ARTICLE 14. ONE AND TWO FAMILY DWELLING CODE

Rule 1. Indiana One and Two Family Dwelling Code (Repealed)

FIGURE R502.8
CUTTING, NOTCHING AND DRILLING

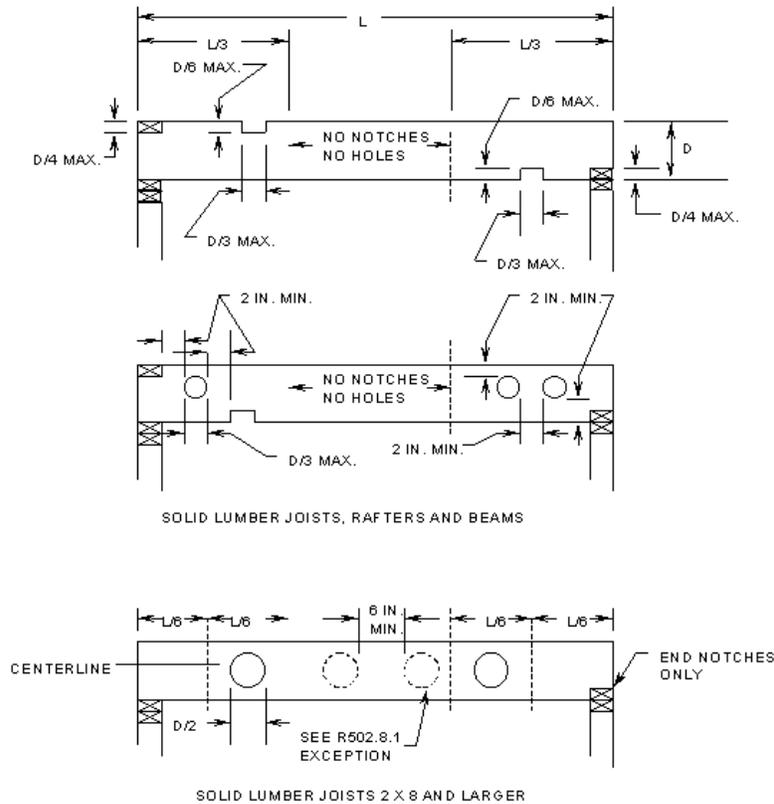
Sec. 88. Delete FIGURE R502.8 and substitute as follows: FIGURE R502.8:

FIGURE R602.6(2)
 NOTCHING AND BORED HOLE LIMITATIONS FOR INTERIOR NONBEARING WALLS

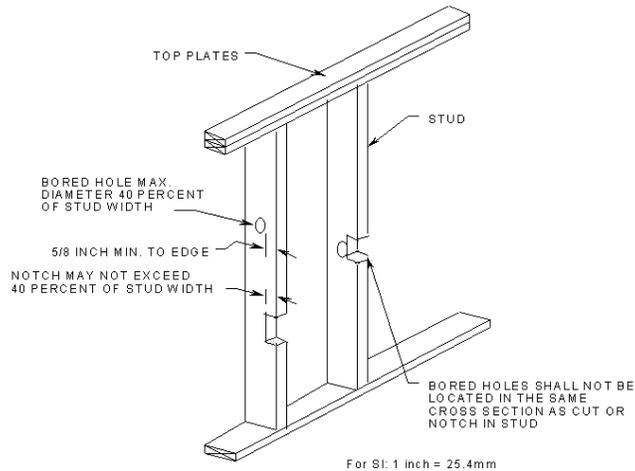
Sec. 95. Delete FIGURE R602.6(2) and insert FIGURE R602.6(2) to read as follows:

FIGURE R602.10.5(2)
GARAGE DOOR BRACED WALL PANEL FOR USE WITH CONTINUOUSLY SHEATHED WALLS

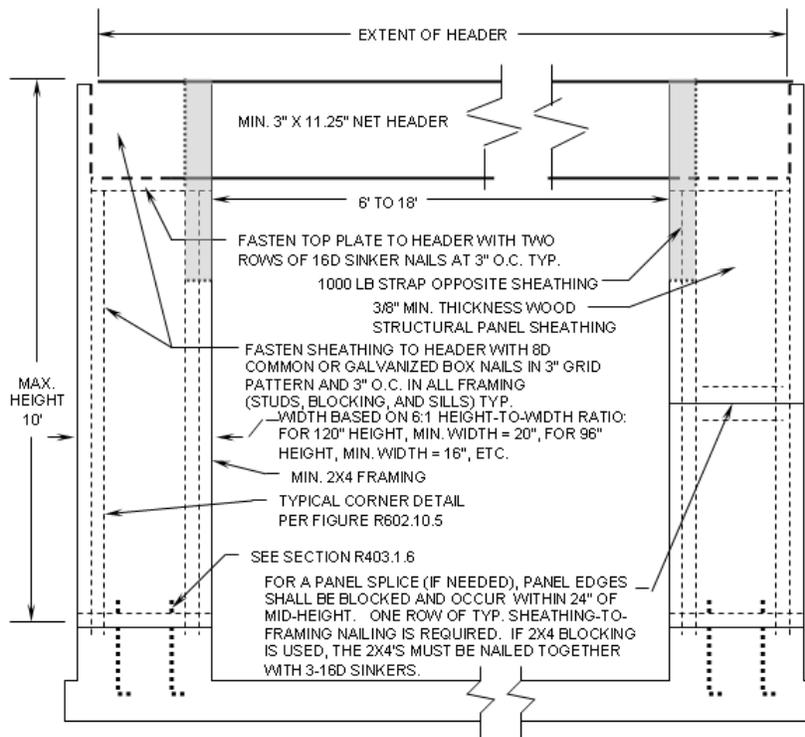
(3) Add an exception to read as follows: Exception: Vertical wall segments in the first of one or first of two story buildings next to garage openings shall be permitted to have 6:1 height-to-width ratio (with height being measured from top of header to sill plate) when constructed in accordance with the following provisions. Each panel shall have a length of not less than 16 inches (406 mm) and a height of not more than 10 feet (3,048 mm). Each panel shall be sheathed on one face with a single layer of 3/8 inch minimum thickness (9.5 mm) wood structural panel sheathing nailed with 8d common or galvanized box nails in accordance with Figure R602.10.5(2). The wood structural panel sheathing shall extend up over the solid sawn or glued-laminated header and shall be nailed in accordance with Figure R602.10.5(2). The header shall extend between the inside faces of the first full-length outer studs of each panel. The clear span of the header between the inner studs of each panel shall be not less than 6 feet (1,829 mm) and not more than 18 feet (5,486 mm) in length. A strap with an uplift capacity of not less than 1,000 pounds (454 kg) shall fasten the header to the side of the inner studs opposite the sheathing. Two anchor bolts shall be installed in accordance with Section R403.1.6, and plate washers shall be a minimum of 2 inches by 2 inches by 3/16 inch (51 mm by 51 mm by 4.8 mm) thick and shall be used on each bolt. This exception is only permitted in Seismic Design Categories A-C.

(4) Add FIGURE R602.10.5(2) to read as follows:

FIGURE R703.7.6(2)

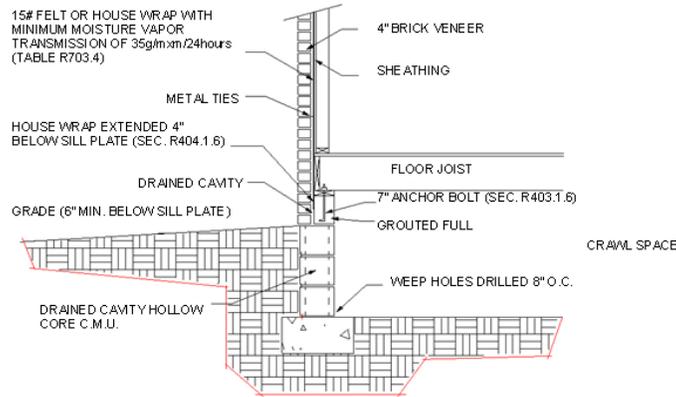
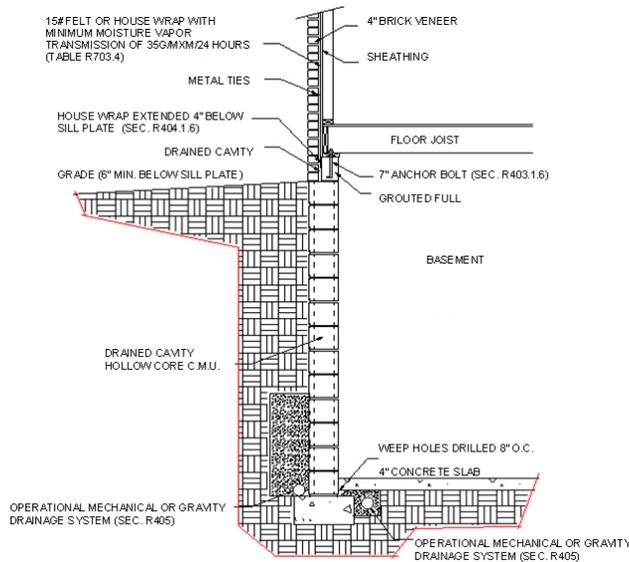
mm) air cavity shall be drained to the exterior of the structure at intervals of not more than 33 inches (838 mm) on center. Each drain shall be not less than $\frac{3}{16}$ inch (4.8 mm) in diameter, located immediately above the flashing. For dwellings with crawl spaces, the air cavity may be drained as shown in FIGURE R703.7.6(1). For dwellings with basements, the air cavity may be drained as shown in FIGURE R703.7.6(2).

FIGURE R1001.6
Chimney Termination

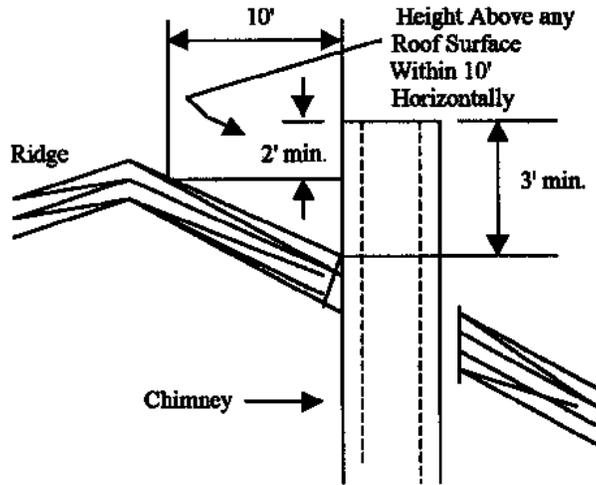
Sec. 135. Add FIGURE R1001.6 as follows:

FIGURE E3801.4.1

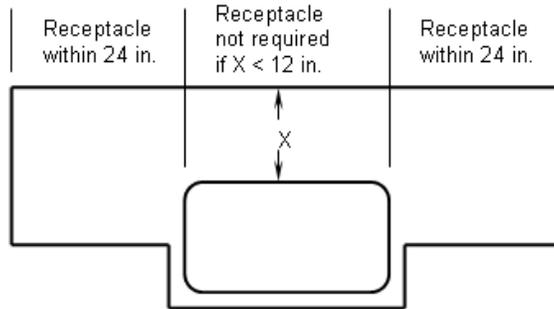
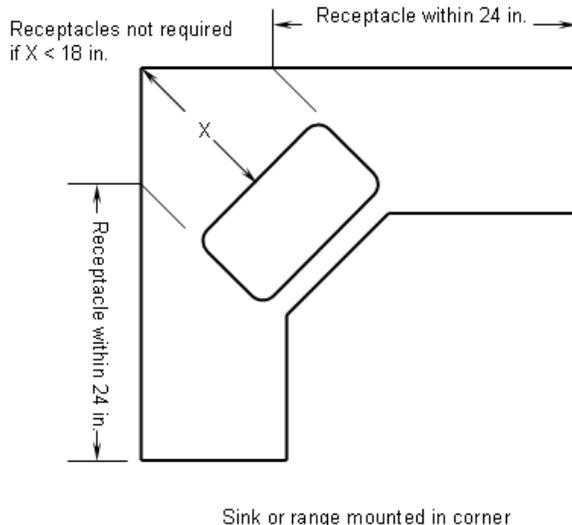
Sec. 229.5. (a) After SECTION E3801.4.1, add an exception to read as follows: Exception: Receptacle outlets shall not be required on a wall directly behind a range or sink in the installation described in FIGURE E3801.4.1.

(b) After SECTION E3801.4.1, add FIGURE E3801.4.1 as follows:
